From: Anna Tidey
Sent: 22 May 2026 20:33:31 UTC+01:00
To: "'Adrian Middle'" <info@lm-associates.co.uk>
Cc: "Jodie.Wilkes@westsussex.gov.uk" <Jodie.Wilkes@westsussex.gov.uk>; "rjfielden1@btinternet.com" <rjfielden1@btinternet.com>; "'Graham Middle'" <graham.middle@lm-associates.co.uk>
Bcc: "drainage" <drainage@midsussex.gov.uk>
Subject: RE: Update on Discharge of conditions application DM/26/0663 at 1A Lodgelands Ardingly Haywards Heath West Sussex RH17 6SD
Attachments: 2026.05.12 Re: DM/26/0663 at 1A Lodgelands Ardingly Haywards Heath West Sussex, RE: WSCC Highways Response To Application Number DM/26/0663 at 1A Lodgelands Ardingly Haywards Heath West Sussex RH17 6SD, RE: Ecologist Response To Application Number DM/26/0663 at 1A Lodgelands Ardingly Haywards Heath West Sussex

Subject: RE: WSCC Highways Response To Application Number DM/26/0663 at 1A Lodgelands Ardingly Haywards Heath West Sussex RH17 6SD

PROPOSED GROUND FLOOR LIGHTING LAYOUT

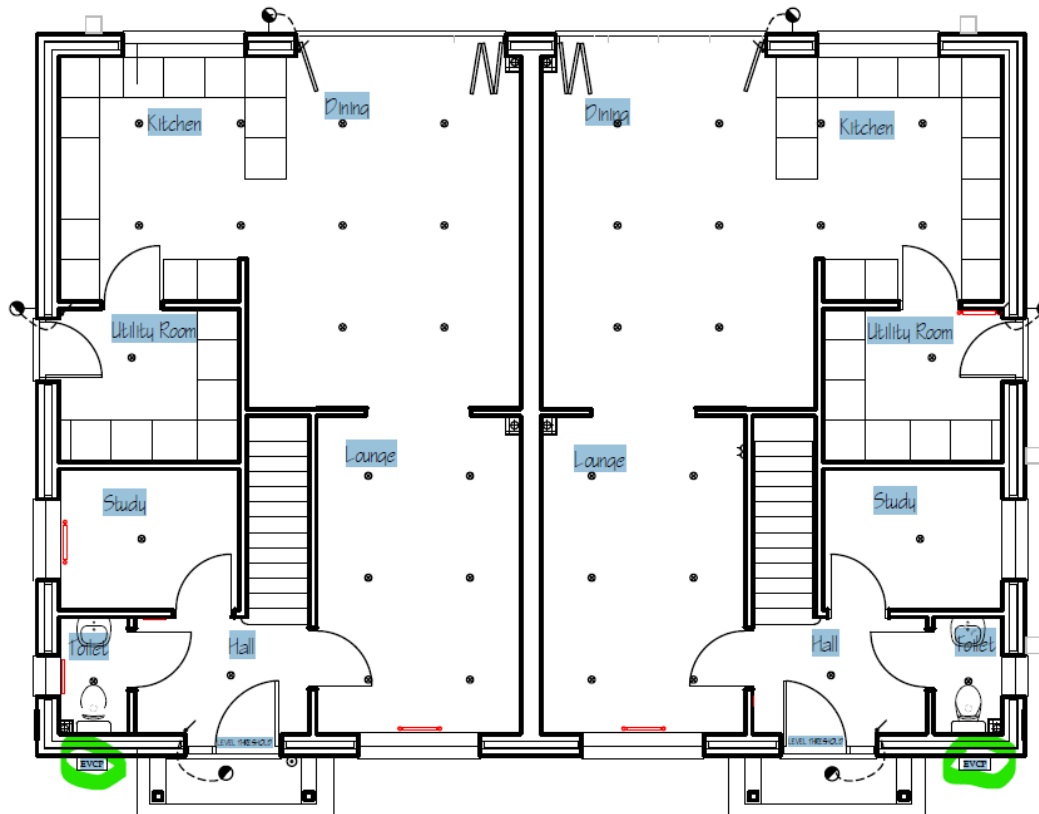
I note the comments that you made with regards to the EV charging provision in your email of 30.04.2026, see attached. Notwithstanding this in order to address the requirements and the wording of the planning condition I shall be grateful if you can confirm the positions for the units are as indicated on the submitted Ground Floor Lighting Layout Plan (highlighted in green on the extract of that plan below)

In addition, and in order to discharge Condition 10 of DM/24/2999, I shall also be grateful if you can provide me with the details of the intended EV Chargers, ie, the product name and related brochure details.

I am just getting around to looking at these plans now and I cannot seem to find any details of the EV Charging units. In my experience a document is usually provided which outlines the make/model and output rates etc of the chargers as well as a plan with their location. Is this what you would be expecting? I note that the proposed Ground Floor Lighting plan appears to show a box to the front of each property with the abbreviations EVCP- I know little about lighting so apologies if this is something else, but this would appear to indicate the location of the charge points and if that is the case, there appears to be no concern with the positioning.

Graham is out the office for a few days, but I have spoken WITH Mr Fielden who confirms he will use a rolec single charging point as attached.

I also confirm the EVCP on the drawing stands for Electric Vehicle Charging Point, as circled green on the drawing. It is worth noting that under Building regulations it is now a requirement under AD-S to provide charging points for electric vehicles.
